Addendum to STAR HFT proposal

January 22, 2008

The STAR HFT upgrade proposal was submitted to BNL in the summer of 2007. It describes the configuration and proposed design of the detector as of that time¹. Since then the simulation work and the R&D effort have continued. In particular, we have improved the design and geometry of the PIXEL detector and we have simplified the IST design and geometry. We have also made substantial improvements to the electronics readout scheme for the PIXEL detector. In part due to these changes, the overall cost range of the proposal has come down.

Figure 1: End view of the new PIXEL geometry. The figure shows the inner and outer sensor layers at their new locations of 2.5 cm and 8.0 cm, respectively.

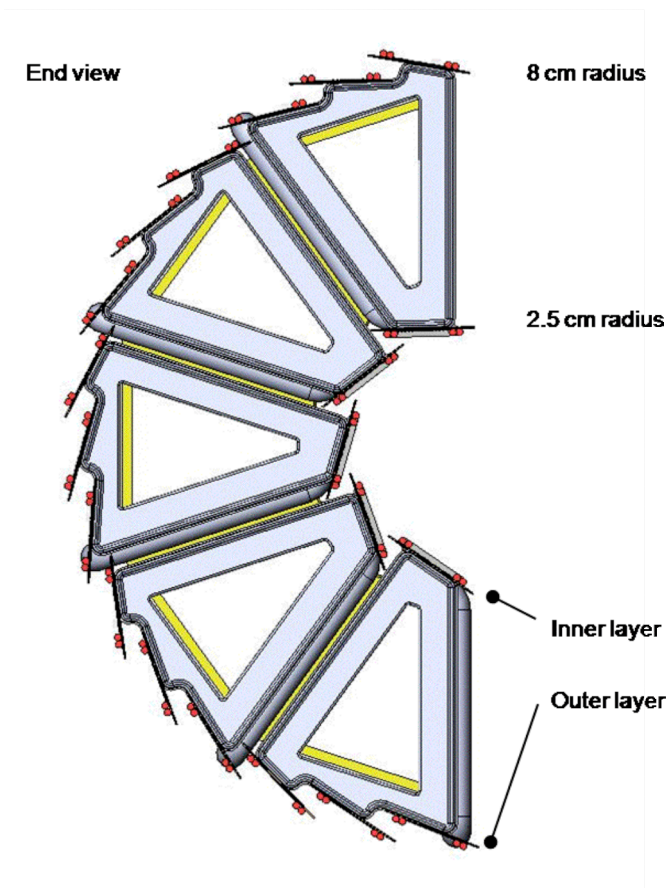
The support and geometry for the pixel sensors have been modified and the new layout is shown in Figure 1. The sensors will be mounted on a trapezoidal ‘box beam’ (similar to the ALICE and CMS detector designs) and we will no longer use individual ladders to support a row of sensors. Each carrier assembly now has 3 rows of outer sensors for each inner row of sensors. The inner layer of sensors will be located at 2.5 cm radius and the outer layer will sit at an average radius of 8 cm. This is a small increase over the ~7 cm outer radius quoted in the proposal.

We have also changed the way the detector is assembled around the beam pipe. We have adopted a clam shell design rather than a three part assembly (section 4.8.1 page 105) which is easier to design and fabricate.

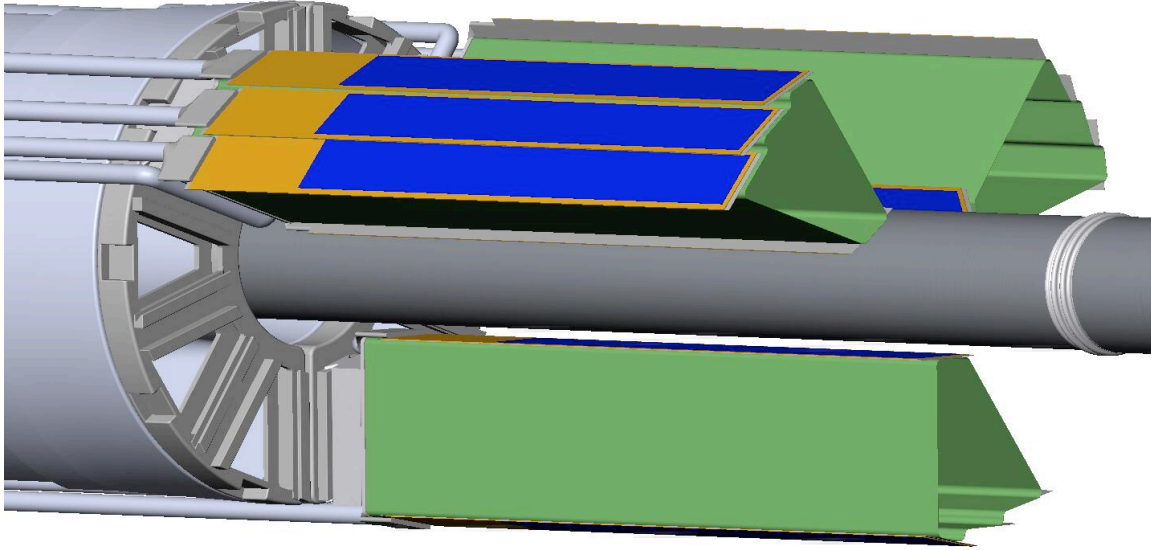
We have also reviewed our plans for a PIXEL engineering prototype. Instead of planning for a full detector with slow sensors (a different technology than our final sensor) we will now implement a small detector patch with prototype sensors that are a milestone on the path towards a final sensor chip.

Figure 3: Geometry of the new single layer IST. There are 23 ladders at an average radius of 14 cm; each with 11 Si sensor modules per ladder and 5 APV 25 readout chips per module.

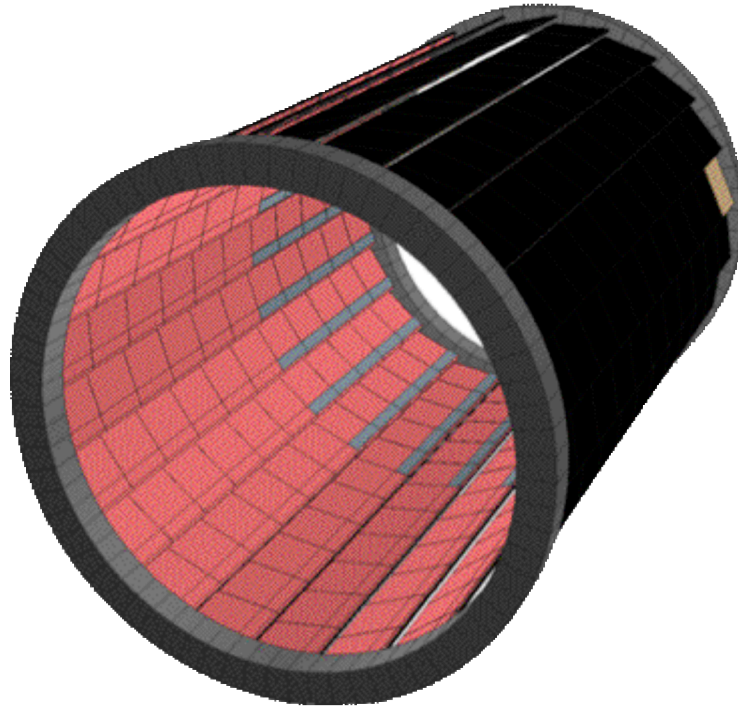
The old layout (proposal configuration) had three silicon layers at two radial locations. The new layout employs one layer of silicon at one radial location. This design minimizes the number of silicon layers and thus minimizes the number of channels (number of readout chips) and reduces the cost. The current design consists of a single layer at a radius of 14 cm, with 23 ladders, and has a length of 44 cm with 11 sensor modules per ladder. Each Silicon pad sensor has a double-metal-layer construction, AC coupled and with an overall size of 4 cm by 4 cm. The final structure is still being

optimized; but pad dimensions of $400\ \mu\text{m} \times 1\ \text{cm}$ are currently anticipated (Section 5.2 page 129-130).

The new configuration has many fewer sensors and readout chips and results in an overall reduction in heat load on the system; but the new scheme requires the use of the more expensive double-metal sensors. A schematic drawing of the new IST geometry and layout is shown in Figure 3.
